STAFF REPORT Docket No. WS-8-24 Summary No.

Major Subdivision South New Orleans Subdivision

Subdivision of Lots 1-19, 26-28, and a portion of Lot 25 into Lot 1A, South New Orleans Subdivision

FIGURE 1

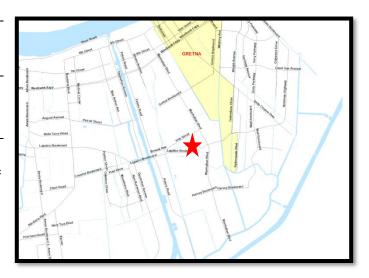
- 4. Public Works states that the area is unsewered. Existing structures located on the property currently have private on-site wastewater treatment but any future development may require an upgrade to the existing on-site wastewater treatment plant.

- The proposed subdivision is bounded by three undeveloped right of ways.
- 7. The proposed lot is encumbered by three servitudes. The proposed Lot 1A has a 10' servitude for Jefferson Parish along Lapalco Blvd, a 5' utility and sidewalk servitude along undeveloped Mathis Ave., and a 20' drainage/sidewalk/utility servitude along undeveloped Twelfth St.
